Index 102-615 Multilane, Work in Intersection

COMMENTARY

COMMENTS AND RESPONSES

LAST REVISION 11/01/20	REVISION	DESCRIPTION:	 FY 2021-22 STANDARD PLANS	MULTILANE ROADWAY, INTERSECTION WORK	INDEX 102-615	SHEET 1 of 5
---------------------------	----------	--------------	--	--------------------------------------	------------------	-----------------

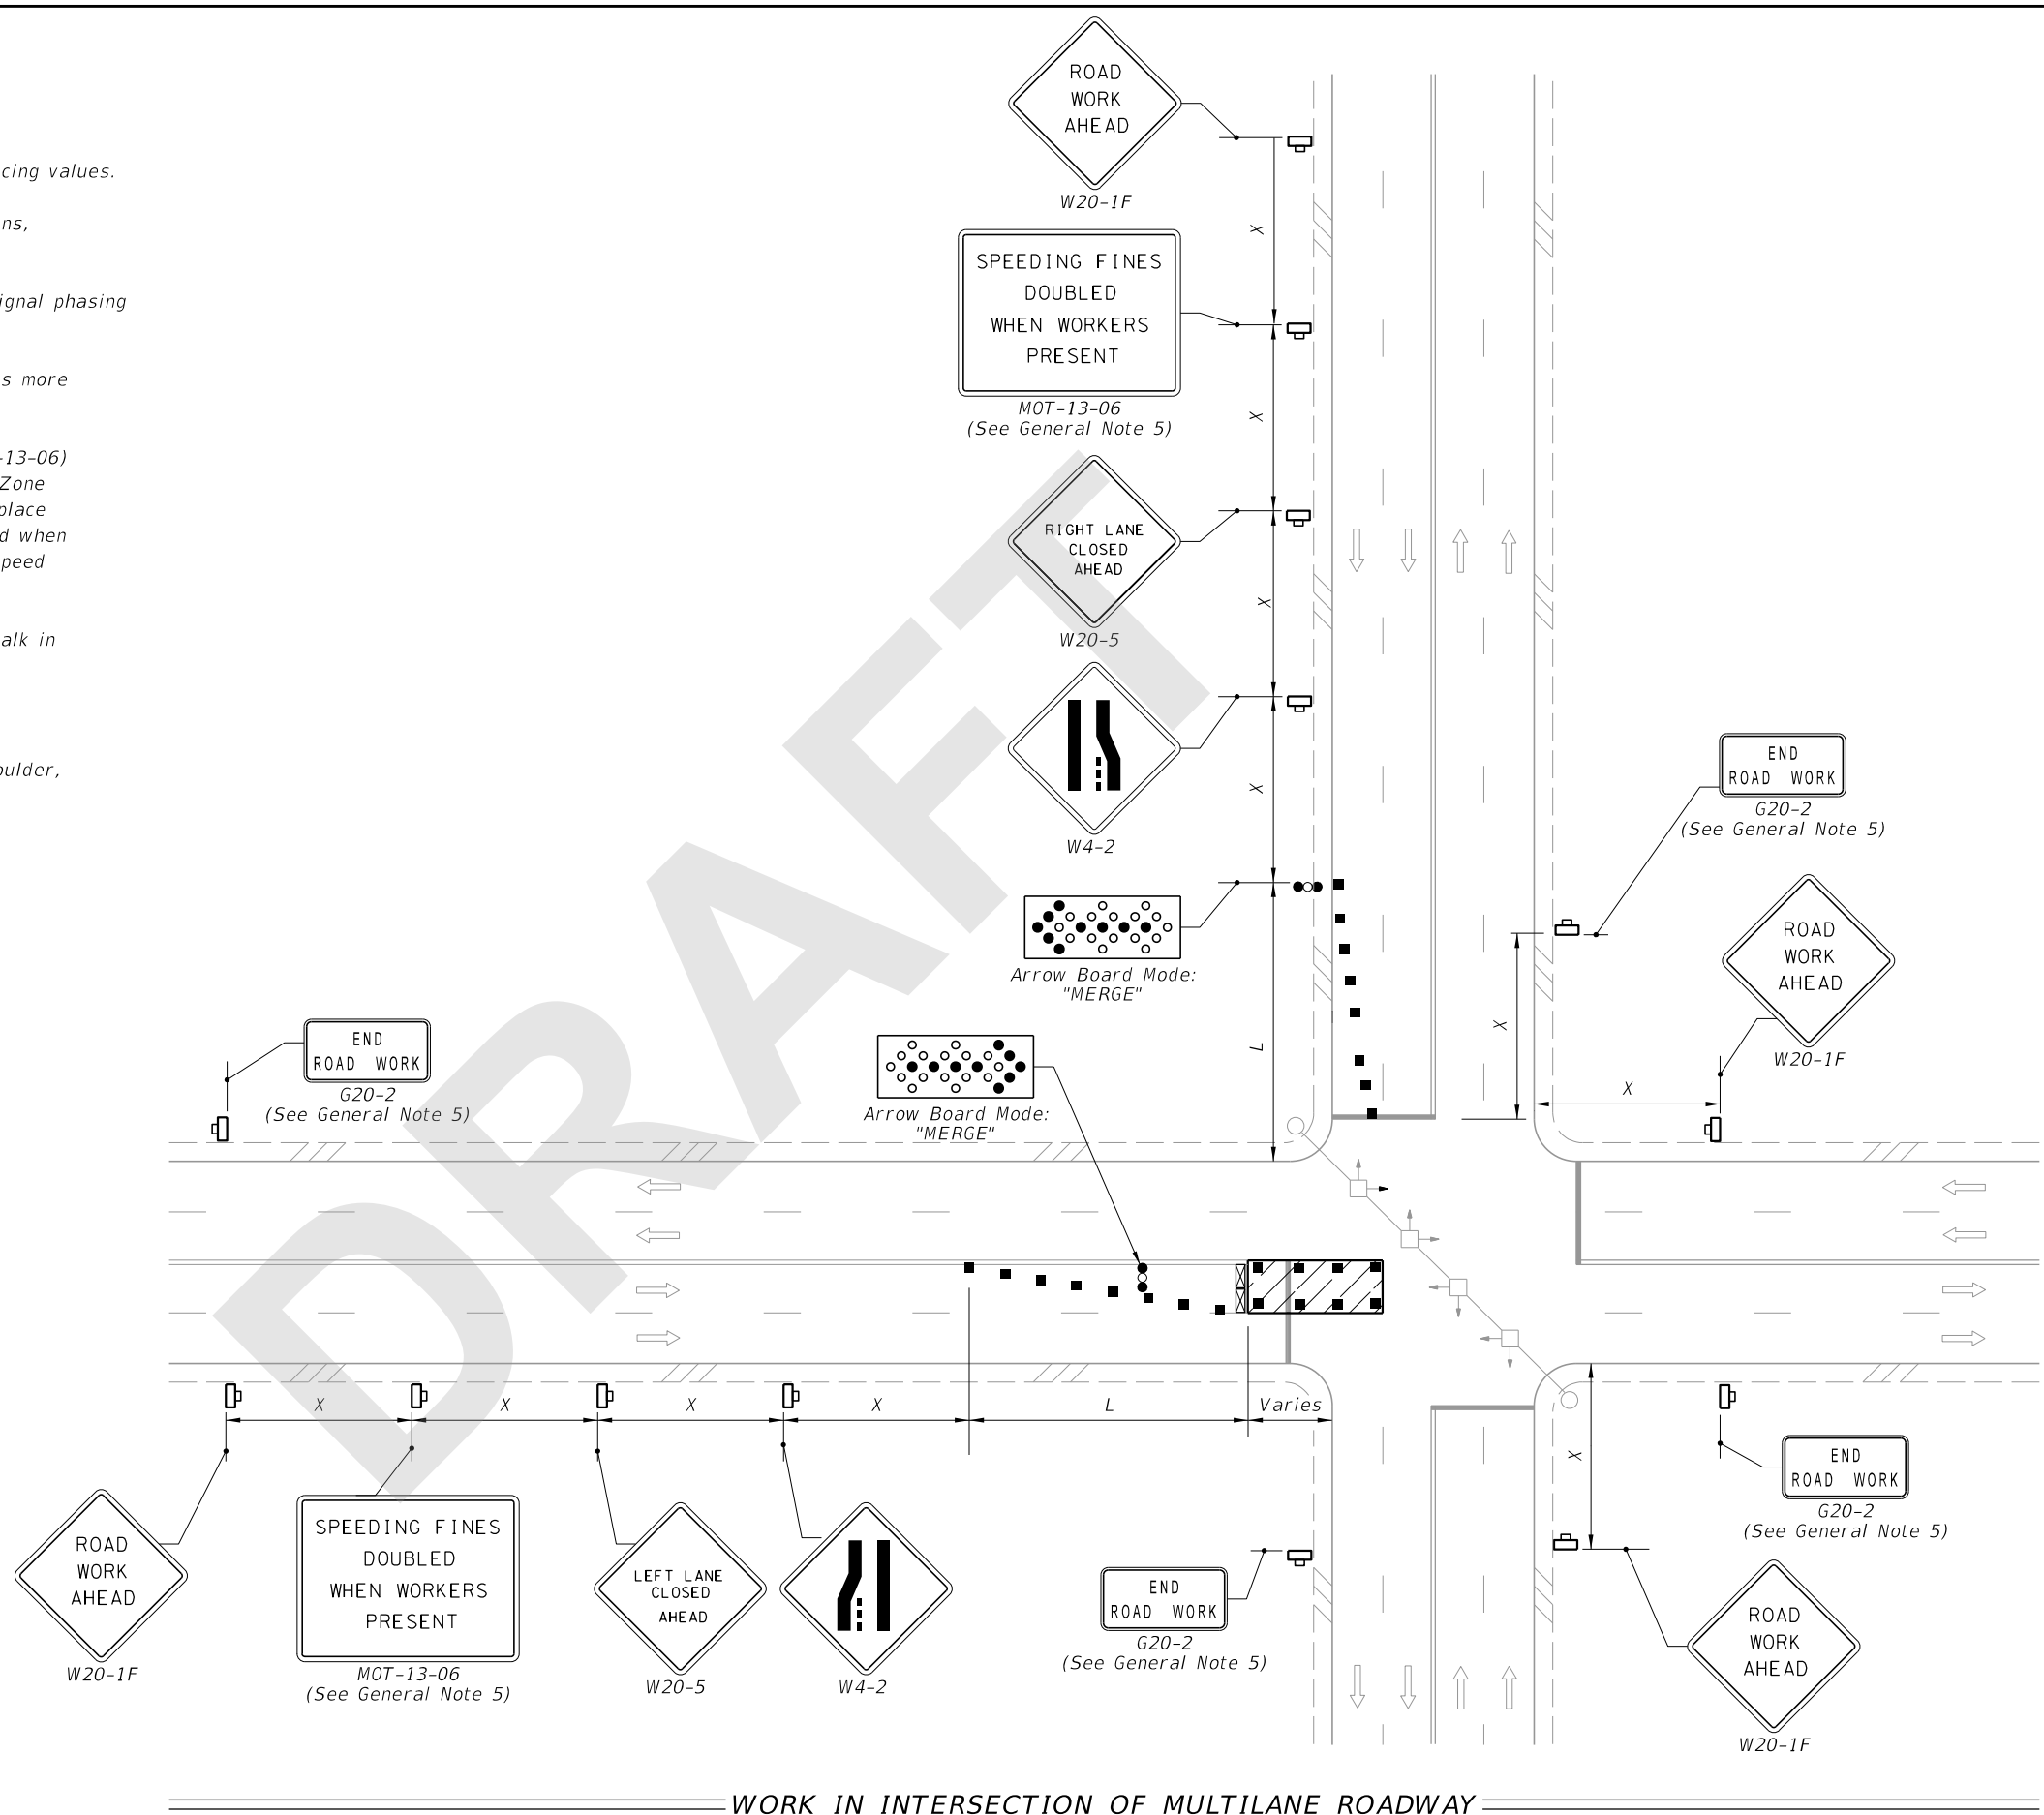
Sheet 1: Revised Detail; Deleted 'Distance Between Signs', and 'Table II Taper Length -Merge' Tables (Moved to 102-600); Deleted Duration Notes and Conditions; Revised 'General Notes'; Changed Index Title.

Sheet 1: editing comment, delete “ ” at end of Note 6 – also consider redrafting sign panels to be consistent with other sheets, sign panel font looks odd in comparison

Sheet 1: Why was the men working sign removed? Where were the duration notes moved too?

RESPONSE: Agreed

RESPONSE: The Signs were updated for consistency throughout the TTC Standard Plans Indexes and the “Person Working” symbol sign is no longer required. Durations notes were revised and added to the General Notes (See Note #5)

LAST REVISION 11/01/20	REVISION	DESCRIPTION:	 FY 2021-22 STANDARD PLANS	MULTILANE ROADWAY, INTERSECTION WORK	INDEX 102-615	SHEET 2 of 5
---------------------------	----------	--------------	----------------------------------	--------------------------------------	------------------	-----------------

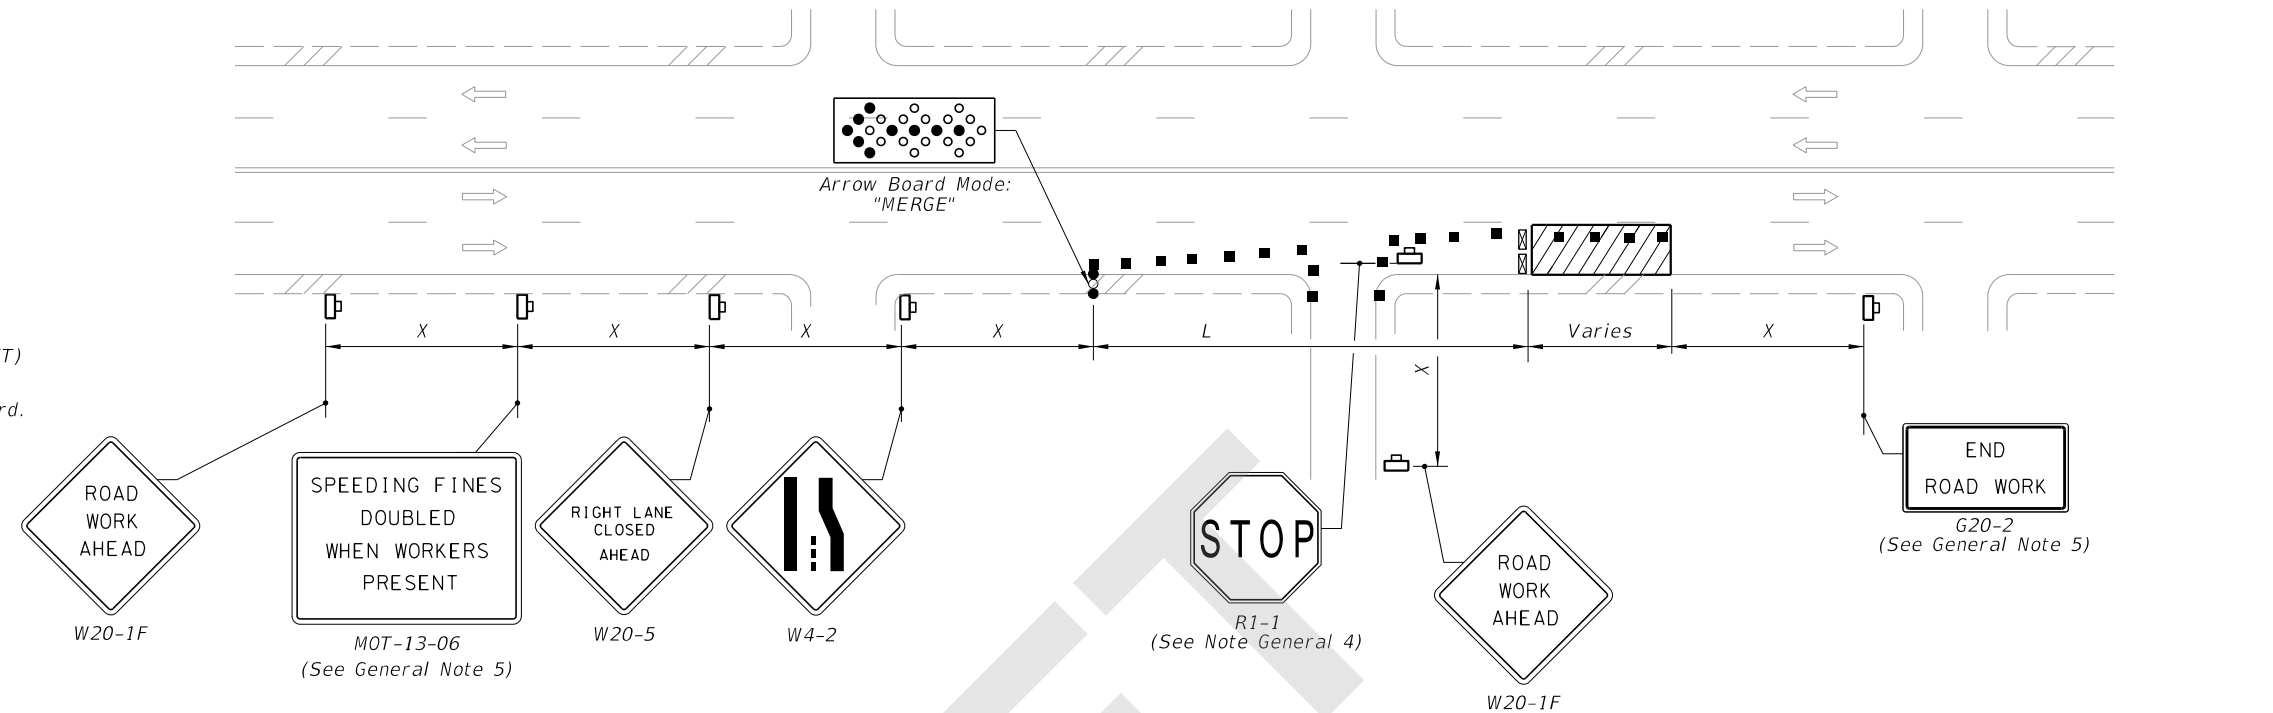
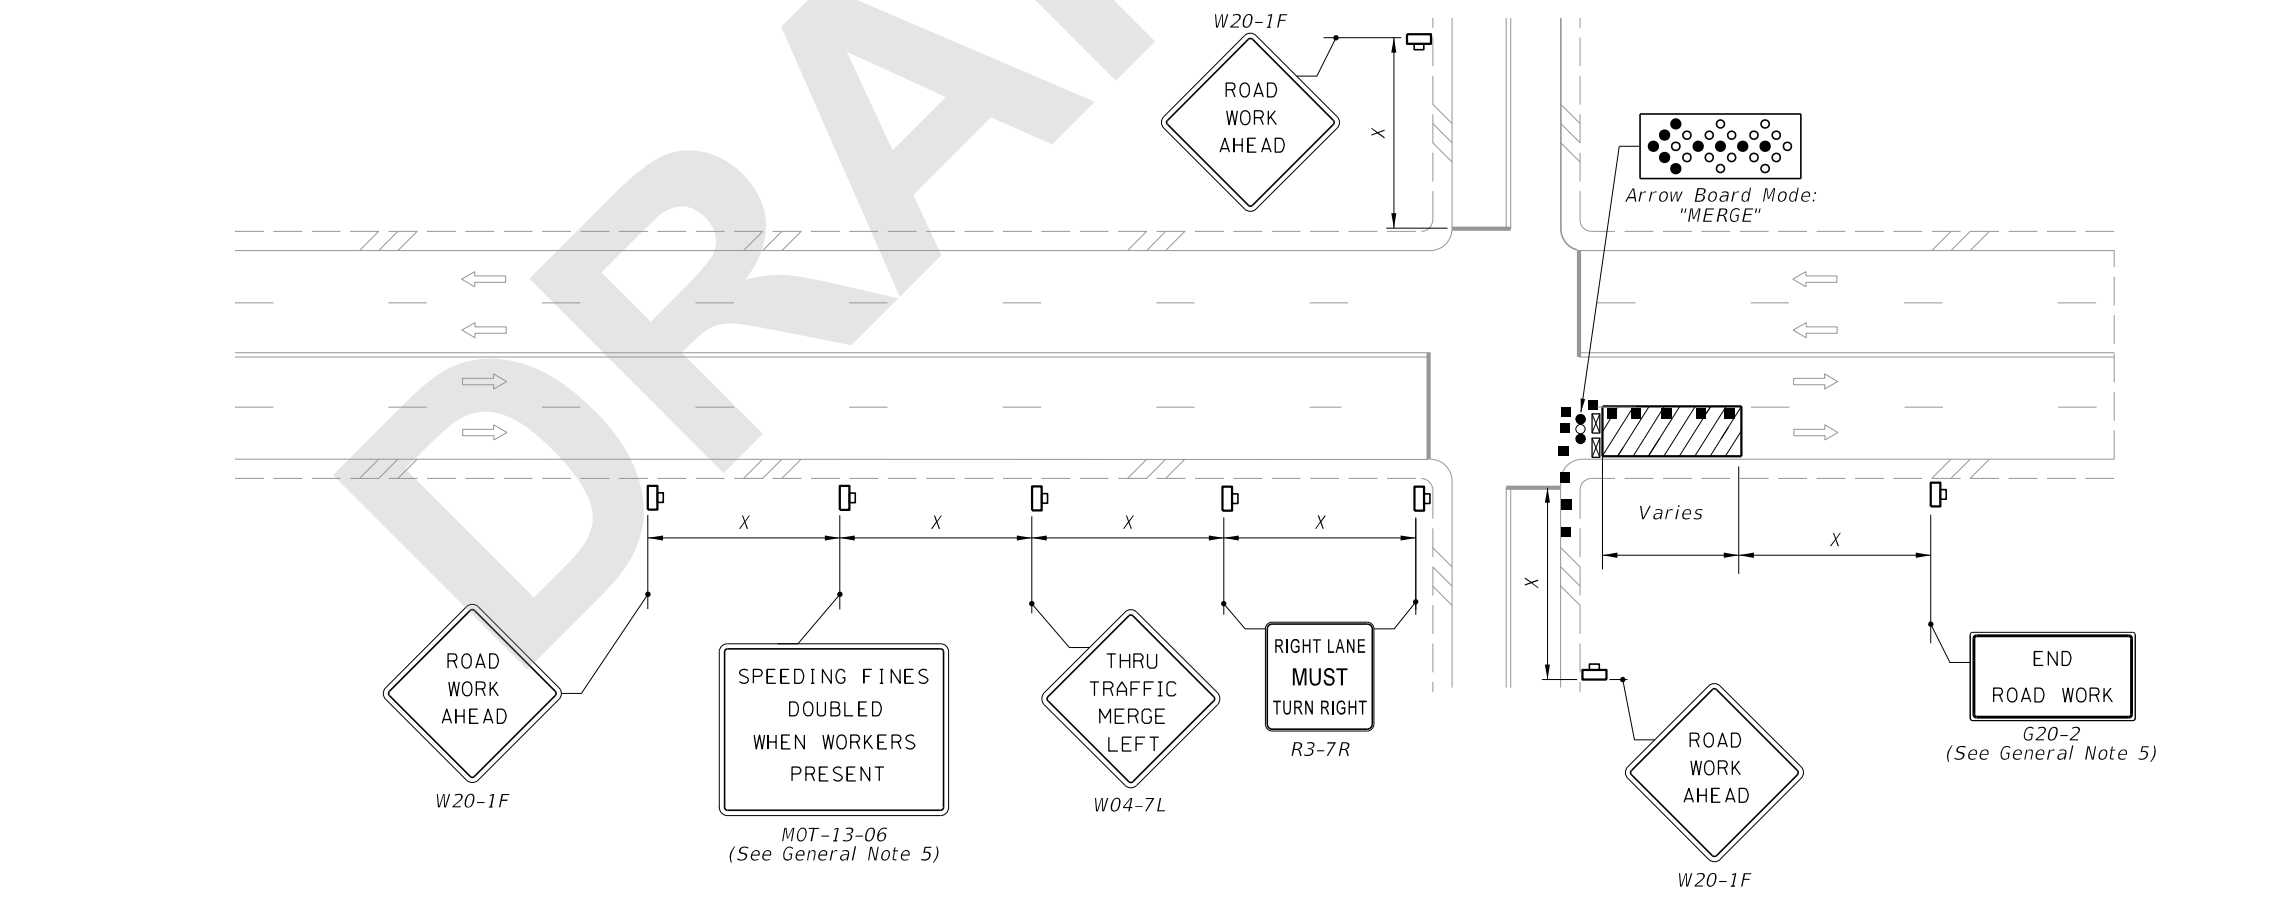
Sheet 2: Added Index 102-616 Sheets 1 and 2 as Sheet 2; Revised Detail; Deleted 'Distance Between Signs', 'Table I Device Spacing', and 'Table II Taper Length -Merge' Tables (Moved to 102-600); Revised Notes; Changed Index Title.

LAST REVISION 11/01/20	REVISION	DESCRIPTION:	 FY 2021-22 STANDARD PLANS	MULTILANE ROADWAY, INTERSECTION WORK	INDEX 102-615	SHEET 3 of 5
---------------------------	----------	--------------	----------------------------------	--------------------------------------	------------------	-----------------

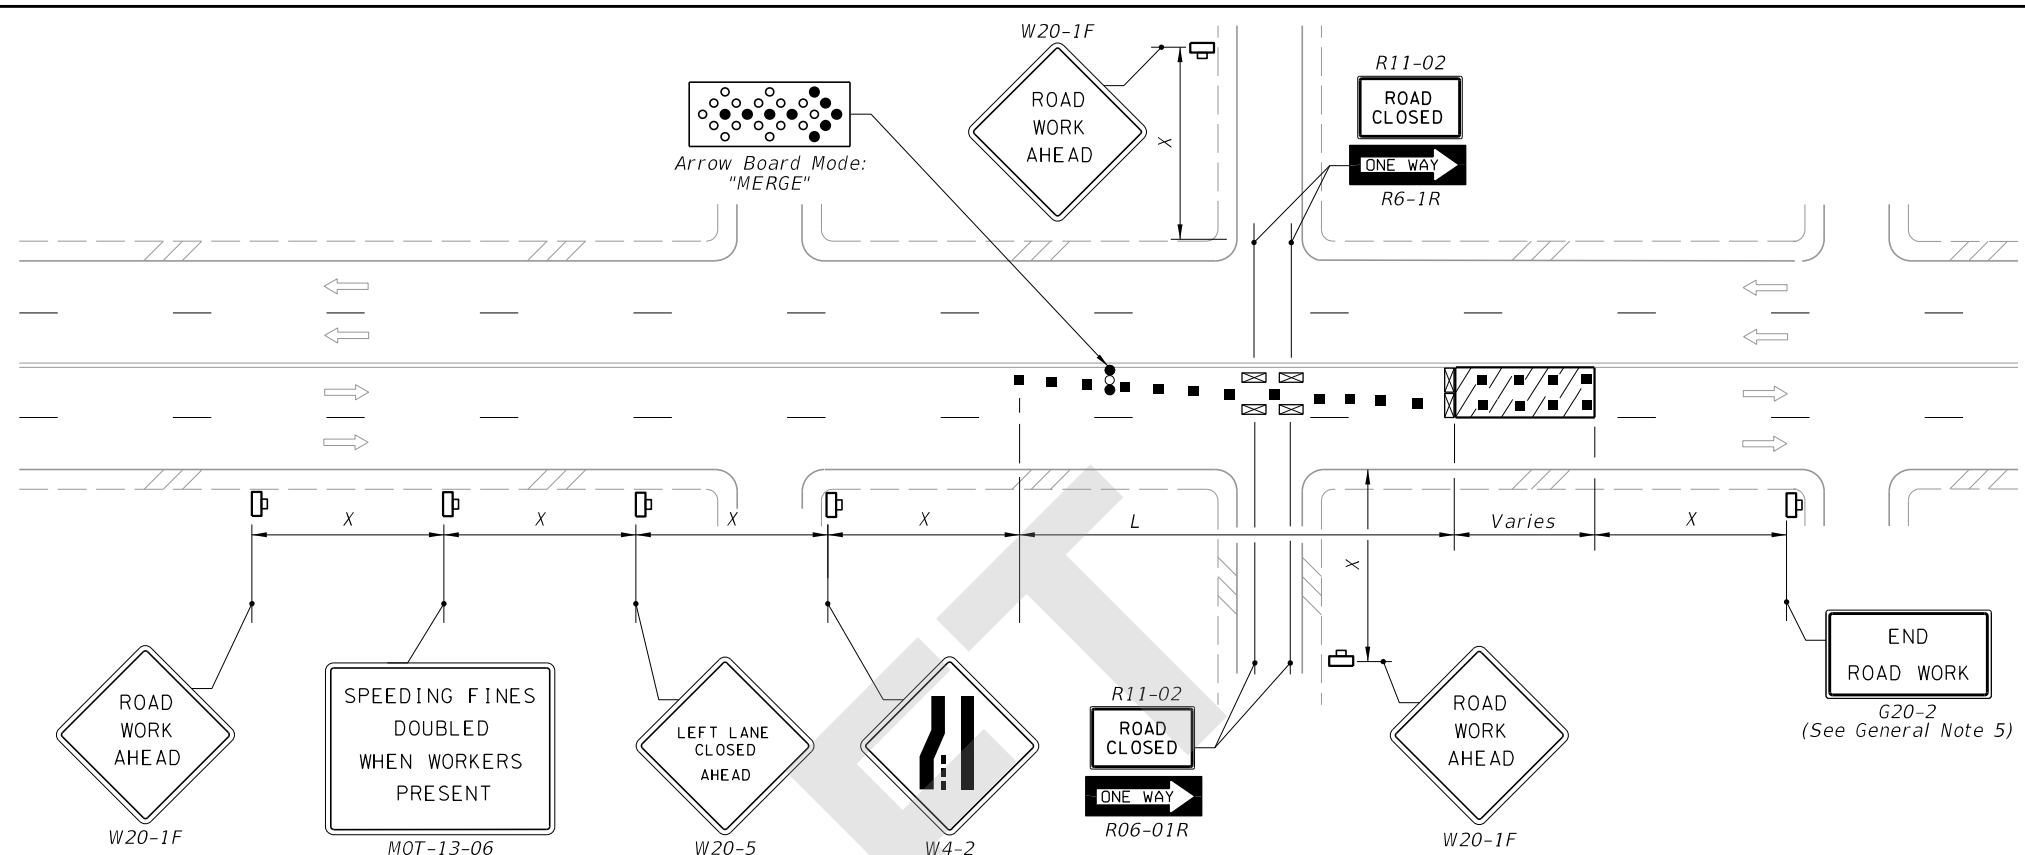
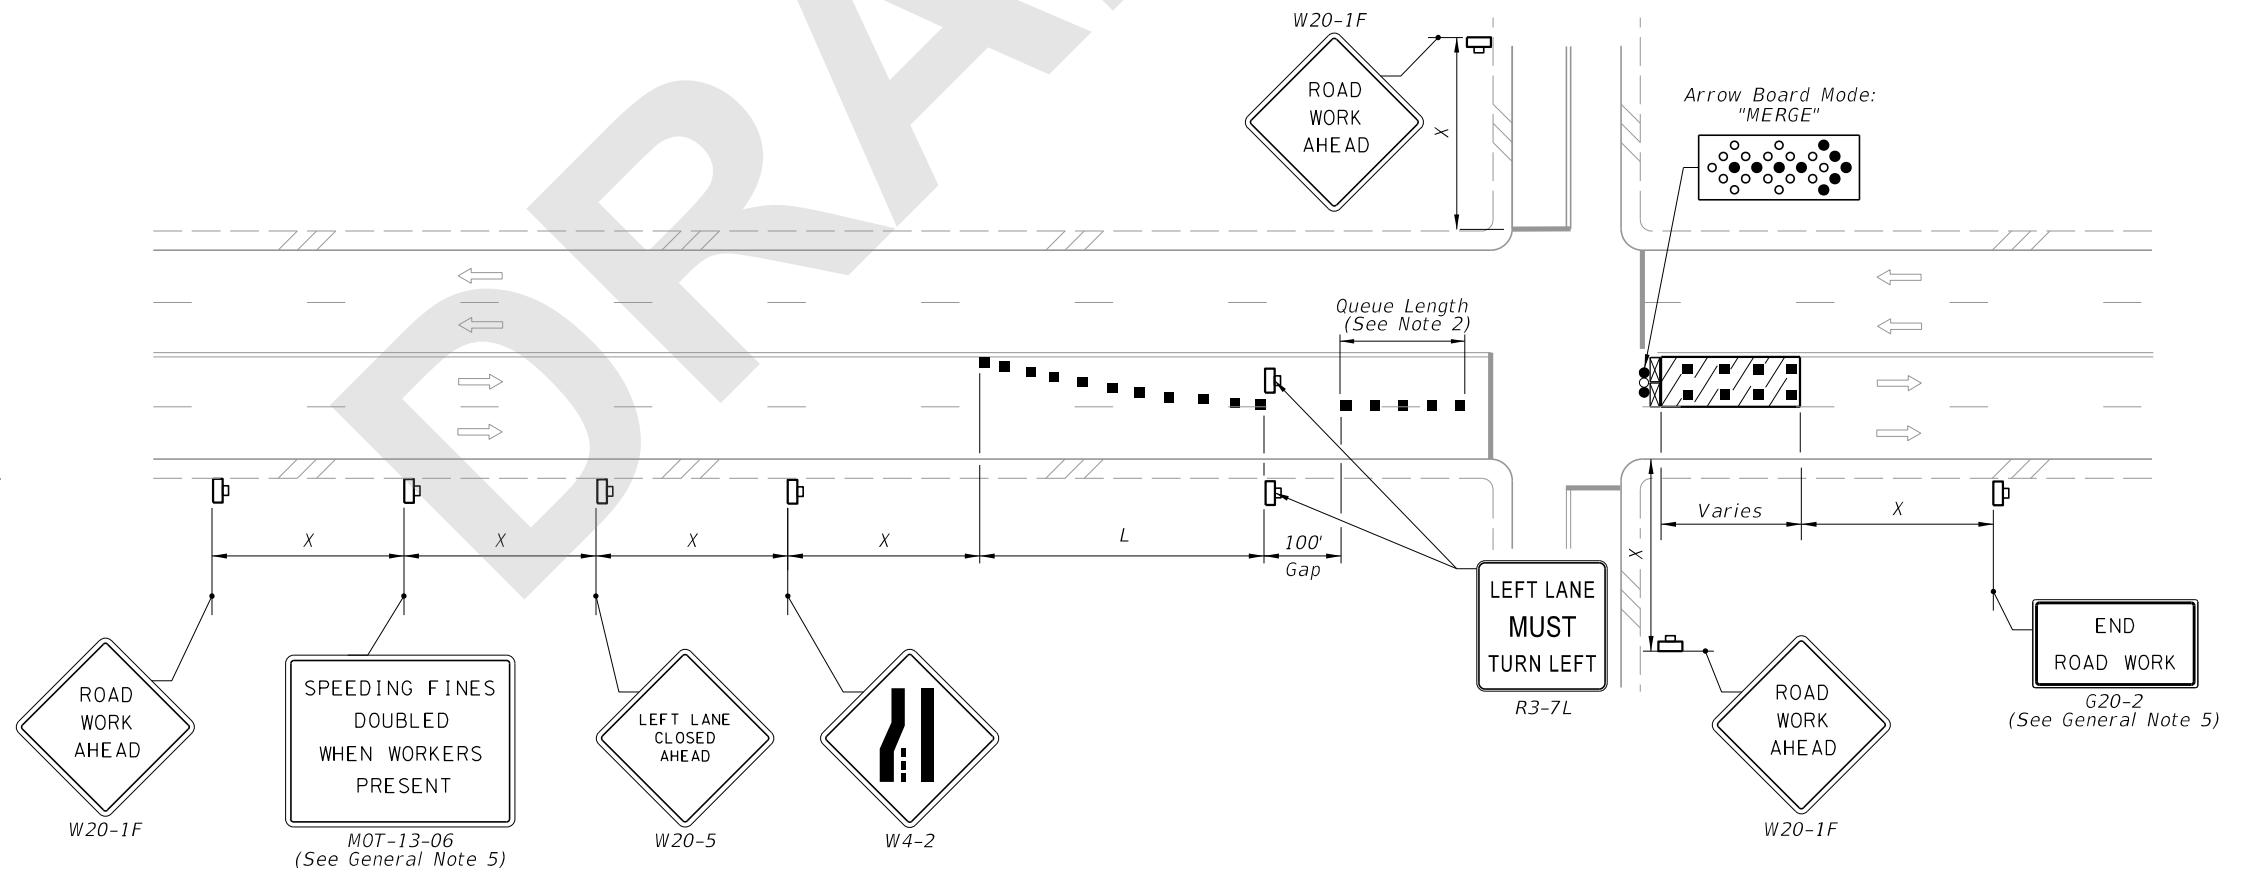
Sheet 3: Added Index 102-616 Sheet 3 as Sheet 3; Revised Details; Deleted 'Distance Between Signs', 'Table I Device Spacing', and 'Table II Taper Length -Merge' Tables (Moved to 102-600); Revised Notes; Changed Index Title.
